Contract #: 04-0120F4Cty: SF/ALA Rte: 80 PM: 13.2/13.9File #: 69.25B**QUALITY ASSURANCE -- NON-CONFORMANCE REPORT****Location:** Changxing Island, Shanghai, P.R. China**Report No:** NCR-000753**Prime Contractor:** American Bridge/Fluor Enterprises, a JV**Date:** 31-May-2010**Submitting Contractor:** Zhenhua Port Machinery Company, Ltd (ZPMC), Changxing Island**NCR #:** ZPMC-0716**Type of problem:**

Reference Description: 4 Missed UT indications found by QA after ZPMC QC has previously tested and accepted these welds in Segment 10CW

Dear: Mr. Charles Kanapicki
Job Name: SAS Superstructure

Subject: NCR No. ZPMC-0716

Description of Non-Conformance:

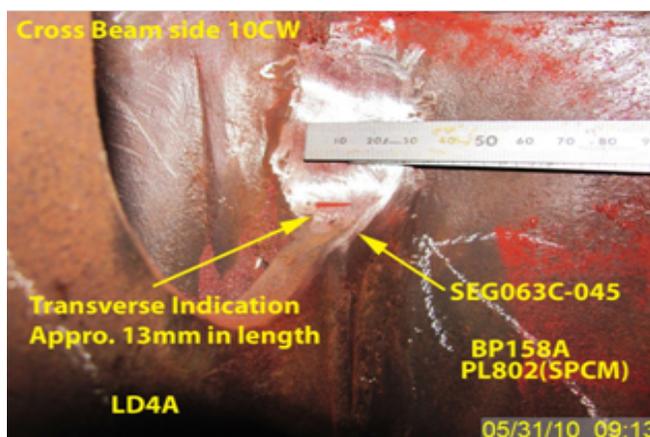
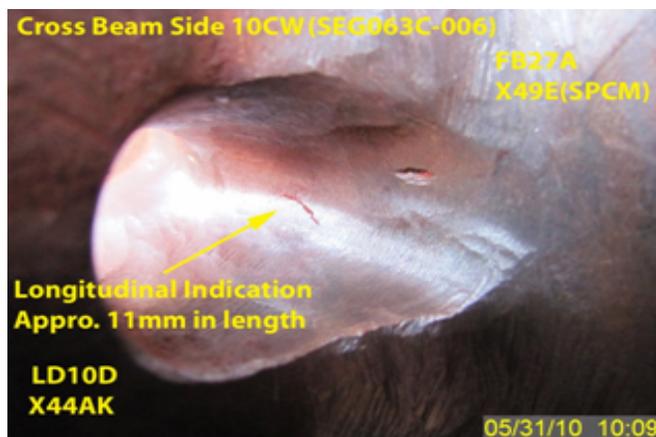
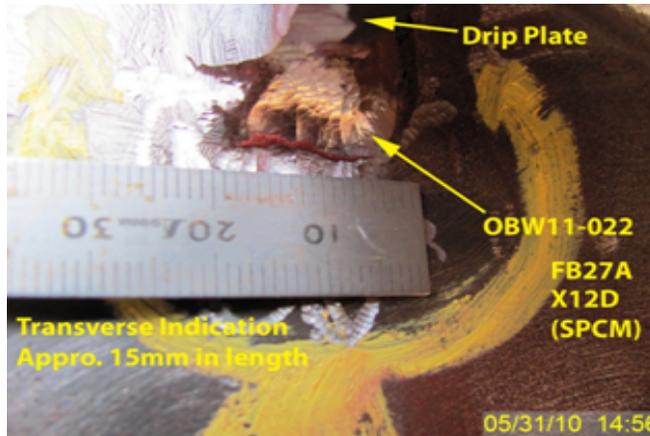
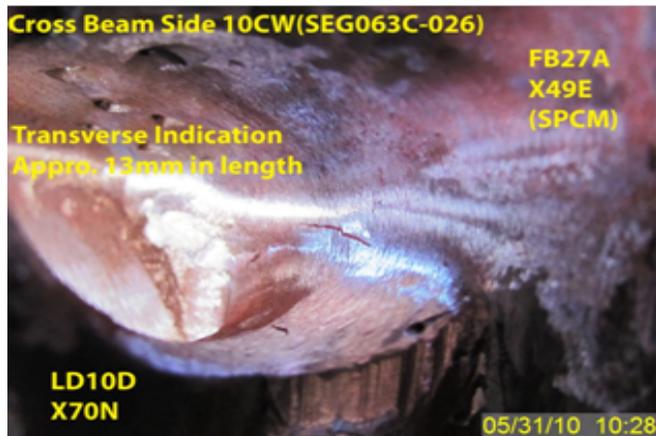
During the Quality Assurance (QA) Magnetic Particle Testing (MT) review of welds located on Segment 10CW, this QA Inspector discovered four (4) linear indications on the following welds:

- Weld #SEG063C-045: One (1) Transverse linear indication measuring approximately 13 mm in length.
- Weld #OBW11-022: One (1) Transverse linear indication measuring approximately 15 mm in length.

- Weld #SEG063C-026: One (1) Transverse linear indication measuring approximately 13 mm in length.
- Weld #SEG063C-006: One (1) Longitudinal linear indication measuring approximately 11 mm in length.

- All indications are clearly marked on the material near the weld.
- All welds are designated as Seismic Performance Critical Material (SPCM).
- Weld SEG063C-045 is a Complete Joint Penetration (CJP) joint joining between LD4A (X68B) Non SPCM to BP158A (PL802A) SPCM at Cross Beam Side.

- Weld OBW11-022 is a fillet weld joint joining between Drip plate to Floor Beam FB27A(X12D) SPCM at Panel Point PP94 (Cross Beam Side).
- The weld SEG063C-026 is a CJP weld joint joining between FB27A (X49E) SPCM to LD10D (X70N) Non SPCM.

- The weld SEG063C-006 is a CJP weld joint joining between FB27A (X49E) SPCM to LD10D (X44AK) Non SPCM.
- OBG segment 10CW is located outside west of Bay#16.

The Notice of Witness Inspection Number (NWIT) is 005839. The indications are located within the area that has been previously tested by ZPMC Quality Control (QC) personnel.

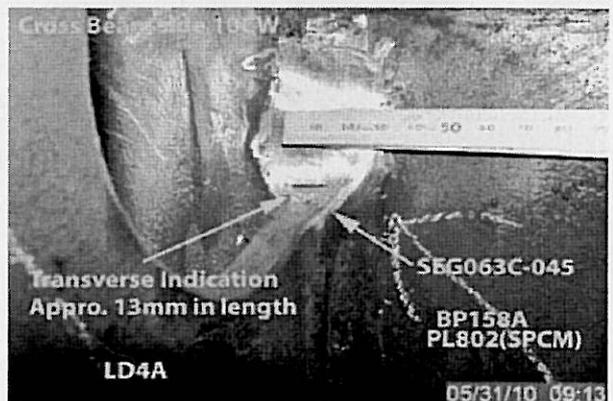
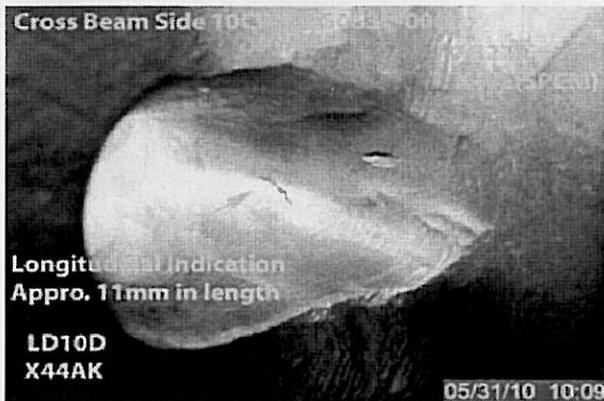
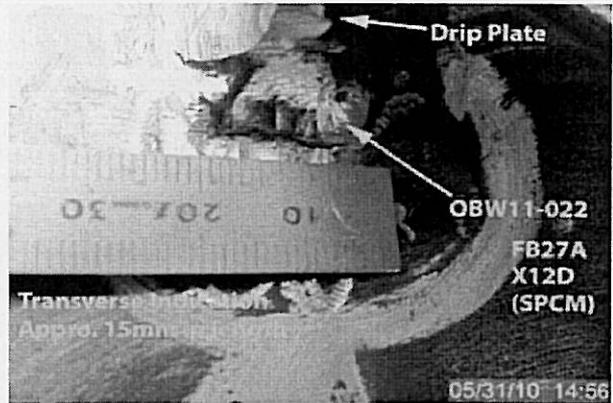
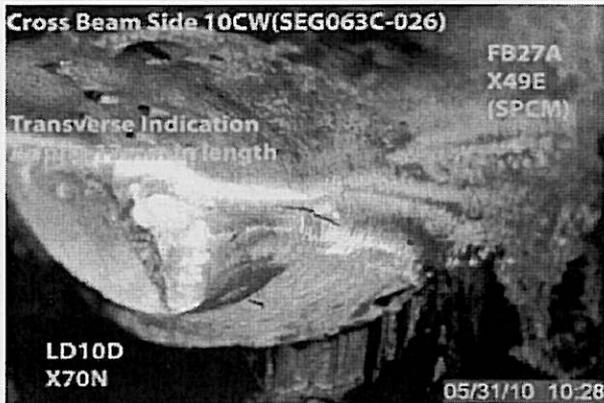
During the Quality Assurance (QA) Magnetic Particle Testing (MT) review of welds located on Segment 10CW, this QA Inspector discovered four (4) linear indications on the following welds:

-Weld #SEG063C-045: One (1) Transverse linear indication measuring approximately 13 mm in length.

-Weld #OBW11-022: One (1) Transverse linear indication measuring approximately 15 mm in length.

-Weld #SEG063C-026: One (1) Transverse linear indication measuring approximately 13 mm in length.

-Weld #SEG063C-006: One (1) Longitudinal linear indication measuring approximately 11 mm in length.

-All indications are clearly marked on the material near the weld.

-The weld SEG063C-026 is a CJP weld joint joining between FB27A (X49E) SPCM to LD10D (X70N) Non SPCM.

-The weld SEG063C-006 is a CJP weld joint joining between FB27A (X49E) SPCM to LD10D (X44AK) Non SPCM.

Description of Non-Conformance:

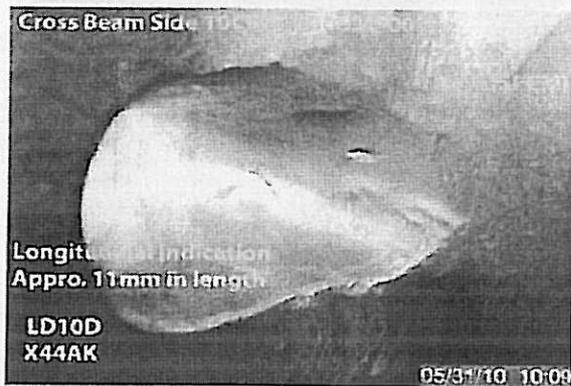
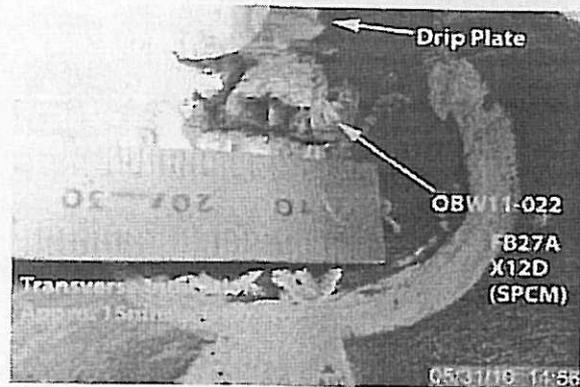
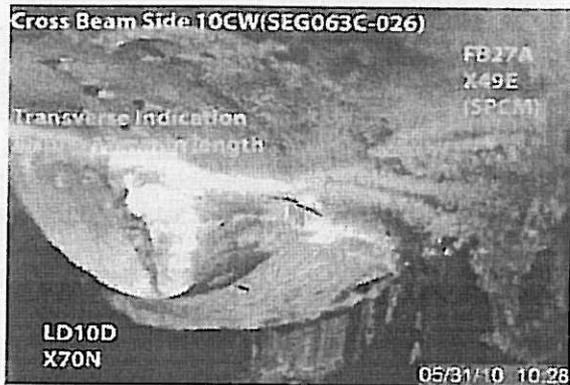
During the Quality Assurance (QA) Magnetic Particle Testing (MT) review of welds located on Segment 10CW, this QA Inspector discovered four (4) linear indications on the following welds:

- Weld #SEG063C-045: One (1) Transverse linear indication measuring approximately 13 mm in length.
- Weld #OBW11-022: One (1) Transverse linear indication measuring approximately 15 mm in length.

- Weld #SEG063C-026: One (1) Transverse linear indication measuring approximately 13 mm in length.
- Weld #SEG063C-006: One (1) Longitudinal linear indication measuring approximately 11 mm in length.

- All indications are clearly marked on the material near the weld.
- All welds are designated as Seismic Performance Critical Material (SPCM).
- Weld SEG063C-045 is a Complete Joint Penetration (CJP) joint joining between LD4A (X68B) Non SPCM to BP158A (PL802A) SPCM at Cross Beam Side.

- Weld OBW11-022 is a fillet weld joint joining between Drip plate to Floor Beam FB27A(X12D) SPCM at Panel Point PP94 (Cross Beam Side).
- The weld SEG063C-026 is a CJP weld joint joining between FB27A (X49E) SPCM to LD10D (X70N) Non SPCM.

- The weld SEG063C-006 is a CJP weld joint joining between FB27A (X49E) SPCM to LD10D (X44AK) Non SPCM.
- OBG segment 10CW is located outside west of Bay#16.

The Notice of Witness Inspection Number (NWIT) is 005839. The indications are located within the area that has been previously tested by ZPMC Quality Control (QC) personnel.
